**Before the
Federal Communications Commission
Washington, DC 20554**

In the Matter of:)
) MB Docket No. **99-325**
Digital Audio Broadcasting Systems and)
Their Impact on the Terrestrial)
Radio Broadcast Service)

REPLY TO OPPOSITIONS

Digital Audio Broadcasting Systems and
Their Impact on the Terrestrial
Radio Broadcast Service
**June 2010 - Reply to Oppositions
of Petition for Reconsideration**

FIGURE A
IBOC CONTOUR OVERLAP
to Class B FM
from 1st Adjacent Class A FM

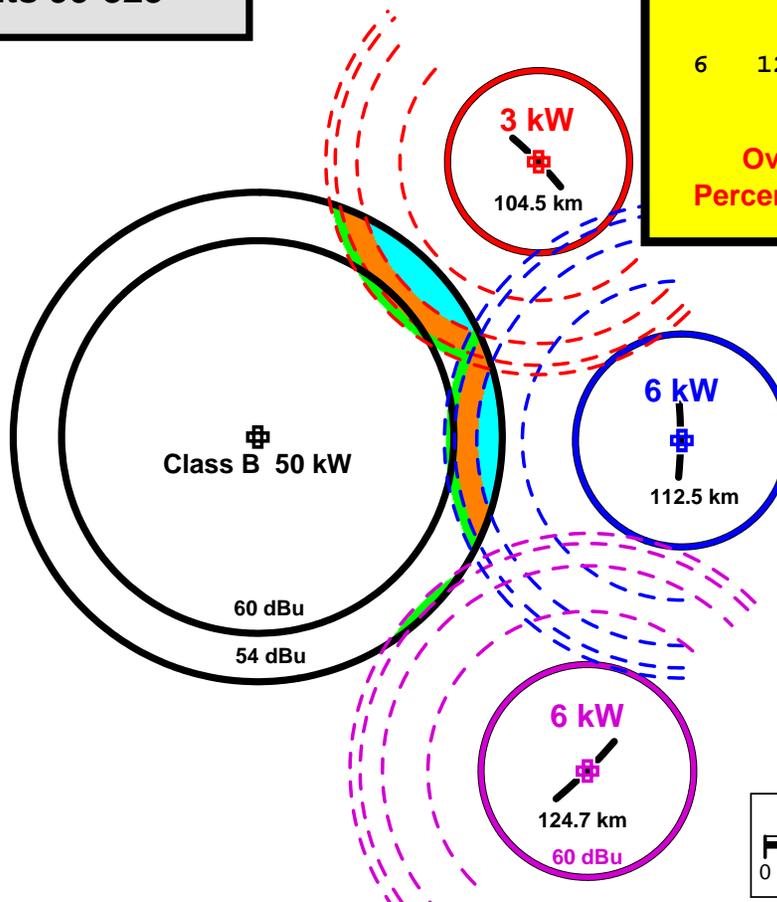
Figure A analyzes the **impact to a Class B by Class A** facilities operating at the minimum separation with maximum Class B & A facilities (both 3 & 6 kW). The overlap clearly penetrates the 54 dBu contour and even slightly inside the 60 dBu of the Class B facility at 10% IBOC power. If full protection of the 54 dBu Class B contour is to be achieved then the required separation of a 6 kW facility at 10% IBOC power must be increased by some 12 km from the current 113 km to 125 km. The separation of 113 km is sufficient at 4% or less IBOC power.

FIGURE B
IBOC CONTOUR OVERLAP
to Class A FM
from 1st Adjacent Class B FM

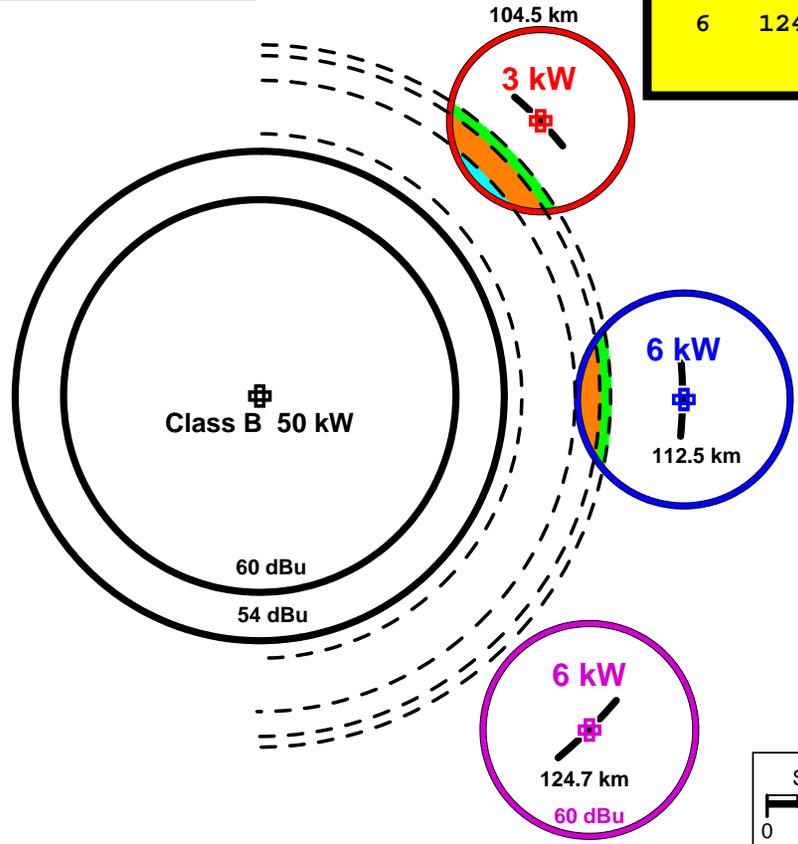
Figure B analyzes the **impact to a Class A by Class B** facilities operating at the minimum separation with maximum Class B & A facilities (both 3 & 6 kW). The overlap of the Class A facility operating with 1% IBOC power clearly penetrates the 60 dBu contour of the **3 kW** Class A by 2.9% of its area, at 4% IBOC by 14.0% and at 10% IBOC by 19.9% of its area. The overlap of the Class A facility operating with 4% IBOC power clearly penetrates the 60 dBu contour of the **6 kW** Class A by 5.0% of its area and

at 10% IBOC by 8.8% of its area. If full protection of the 60 dBu Class A 6 kW contour is to be achieved then the required separation of a 50 kW facility must be increased at 4% IBOC power by some 6 km from the current 113 km to 118 km and at 10% by 9 km to 122 km.

**FIGURE C - 6 kW
IBOC CONTOUR OVERLAP
to Class A FM
from 1st Adjacent Class A FM**

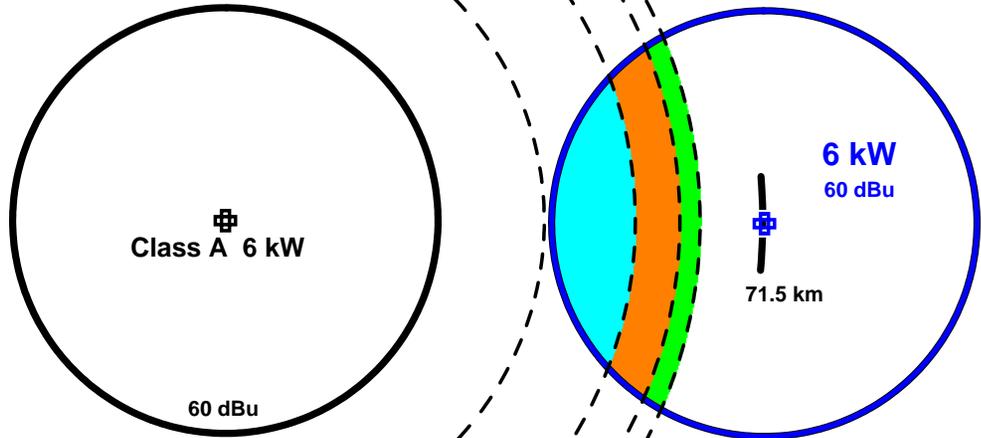
Figure C analyzes the **impact to a 6 kW Class A by another 6 kW Class A** facilities operating at the minimum separation with maximum facilities. The overlap of the Class A facility operating with 1% IBOC power clearly penetrates the 60 dBu contour of the **6 kW** Class A by 11.7% of its area, at 4% IBOC by 22.0% and at 10% IBOC by 27.3% of its area. If full protection of the 60 dBu Class A 6 kW contour is to be achieved then the required separation of a 6 kW facility at 1% IBOC must be increased by some 11 km from the current 72 km to 83 km, at 4% by 17 km to 89 km and at 10% by 20 km to 92 km.
